R. E. GINNA NUCLEAR POWER PLANT

AMENDMENT TO FACILITY OPERATING LICENSE

Amendment No. 15
License No. DPR-18

ATTACHMENT TO LICENSE AMENDMENT NO. 15

Figure 3.1-1 Reactor Coolant System Heatup Limitations Applicable for 21.0 Effective Full Power Years. $T_{\text{ERROR}} = 10^{\circ}\text{F}$, $P_{\text{ERROR}} = 60 \text{ PSI}$

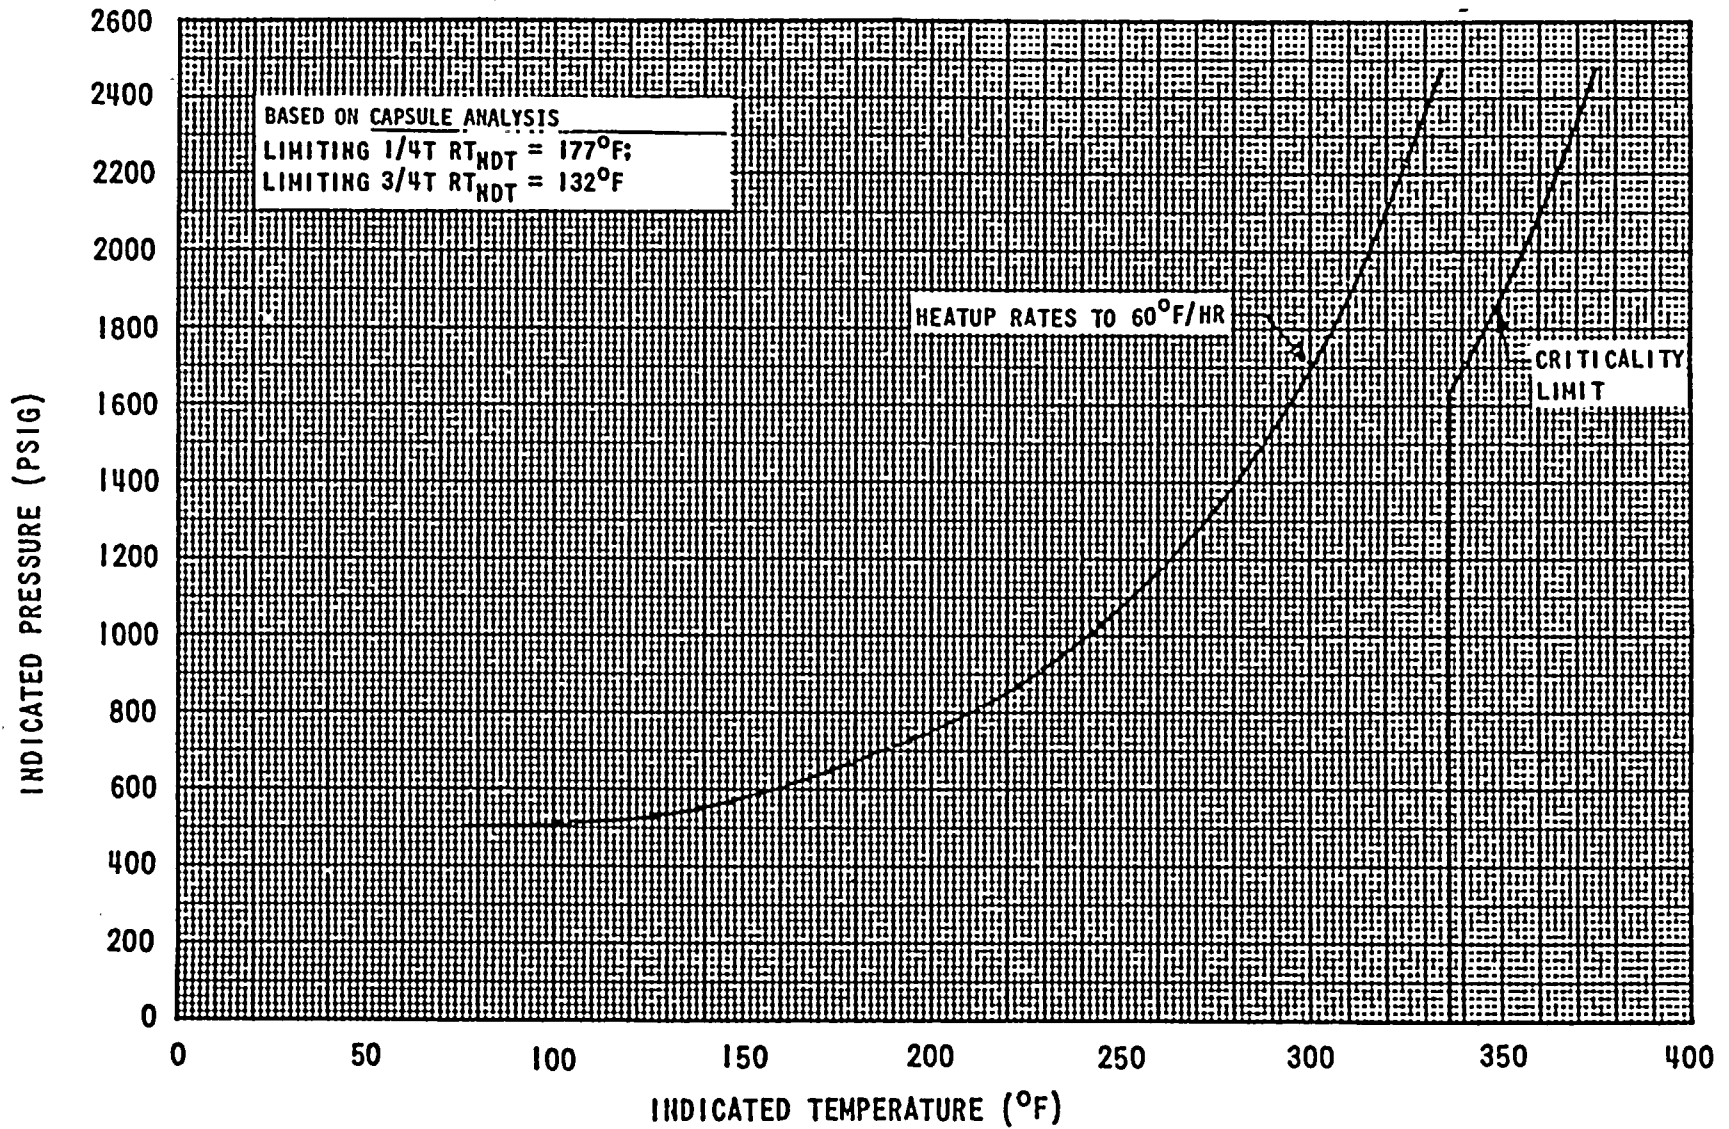
3.1.2.1 The reactor coolant temperature and pressure and system heatup and cooldown rates (with the exception of the pressurizer) shall be limited in accordance with Figures 3.1-1 and 3.1-2 for the first 21.0 effective full power years.

a. Allowable combinations of pressure and temperature for specific temperature change rates are below and to the right of the limit lines shown. The heatup and cooldown rates shall not exceed 60°F/hr and 100°F/hr, respectively. Limit lines for cooldown rates between those presented may be obtained by interpolation.

b. Figures 3.1-1 and 3.1-2 define limits to assure prevention of non-ductile failure only. The limit lines shown in Figures 3.1-1 and 3.1-2 shall be recalculated periodically using methods discussed in the Basis Section.

Figure 3.1-2 Reactor Coolant System Cooldown Limitations Applicable for 21.0
Effective Full Power Years. $T_{ERROR} = 10^{\circ}F$, $P_{ERROR} = 60$ PSI

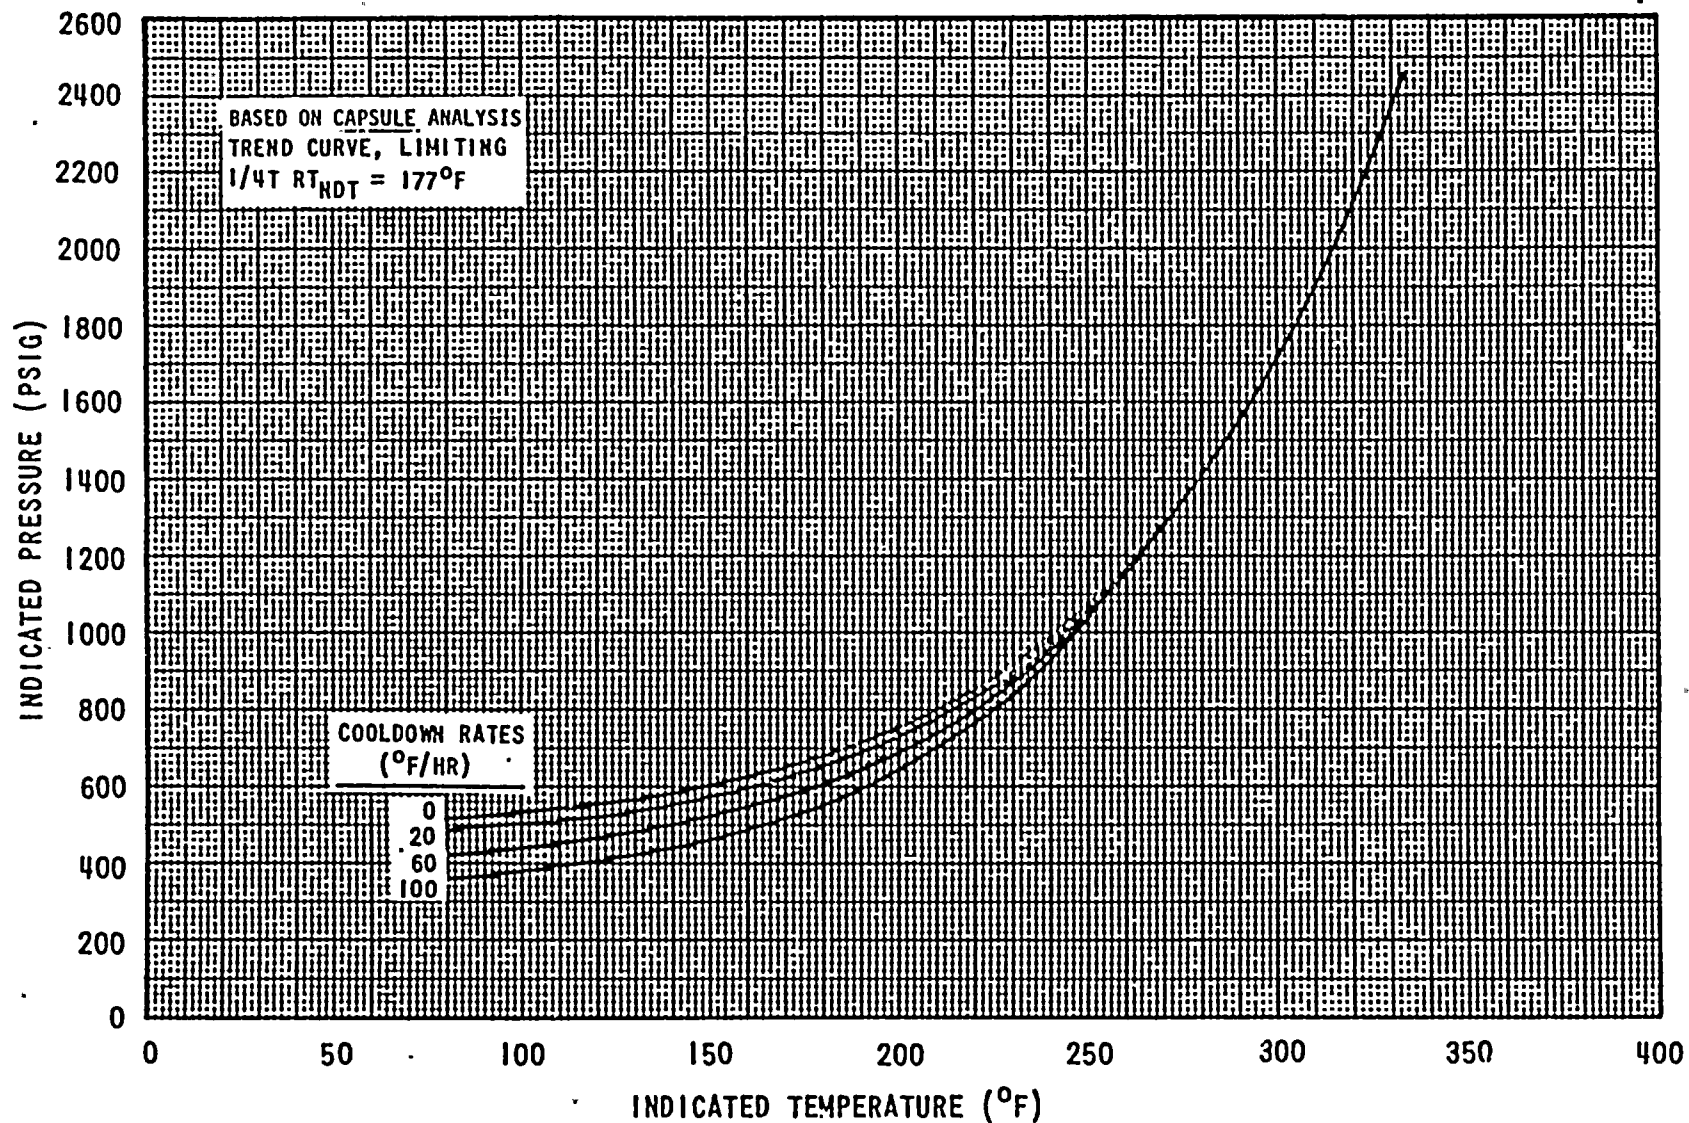
Because operation control is on coolant temperature and cooldown rate may vary during the cooldown transient, the limit curves shown in Figure 3.1-2 represent a composite curve consisting of the more conservative values calculated for steady state and the specific cooling rate shown.
